<h1>CHANGE ORDER</h1>	CHANGE ORDER NUMBER
		11
		4/11/2025
		Page 1 of 5

<input checked="" type="checkbox"/> ORDERED BY ENGINEER UNDER SECTION 1-04.4 OF THE STANDARD SPECIFICATIONS. <input type="checkbox"/> CHANGE PROPOSED BY CONTRACTOR	PROJECT IDENTIFICATION PROJECT NAME: 36 th Avenue W & 35 th Avenue W, 164 th St SW to SR 99 PROJECT NUMBER: RC1783, RC1784, RR6337, RR6342, UPI 06-0014 Fed Aid #: STBGUL-2585(001)
CONTRACTOR ENDORSEMENT: <div> <div>Kenton Wilde</div> <div> <small>Digitally signed by Kenton Wilde DN: C=US, E=kenton@marshbankconst.com, O=Marshbank Construction Inc, CN=Kenton Wilde Date: 2025.04.23 07:53:56-07'00'</small> </div> </div>	CONTRACTOR: Marshbank Construction, Inc.
<div> <div>SIGNATURE</div> <div>DATE</div> </div> Vice President	ADDRESS: PO Box 97 3304 Old Hartford Rd Lake Stevens, WA 98258
<div>TITLE</div>

Description
This Change Order compensates the Contractor for removing and replacing existing storm drainage pipe runs and catch basins from Station 94+00 to 110+30 and as shown on revised plan sheets DR05 through DR07. Prior to removal, the Contractor shall record existing rim and invert at existing catch basins and reinstall the new storm drainage to m

REFERENCE
SHEET NO.
DR07
SHEET
76
OF
163
SHEETS

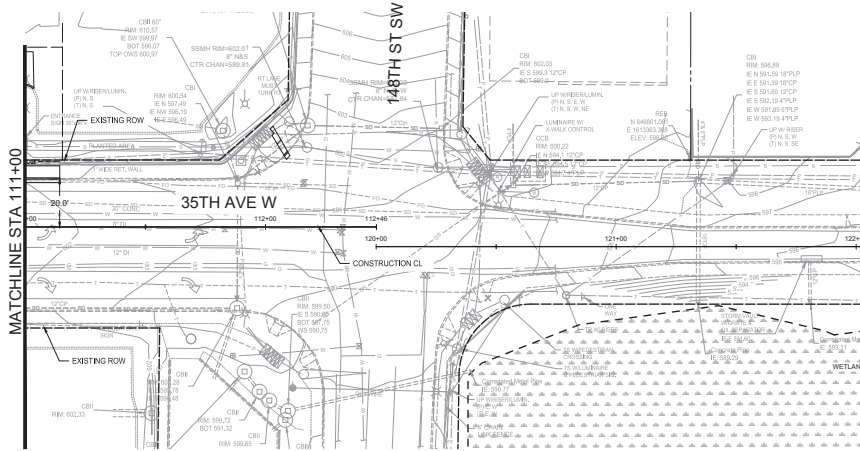
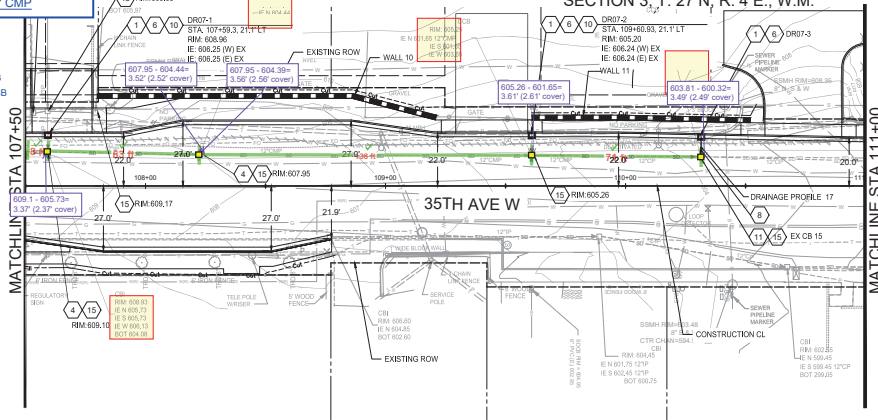
Existing GREEN LINE = 12" CMP
Existing BLUE LINE = 18" CMP

Ductile
Replacement

Replace - Existing Type 1 CB
Replace - Existing Type 1L CB

MAINTAIN EXISTING
ELEVATIONS FOR
REPLACEMENT PIPE
AND STRUCTURES
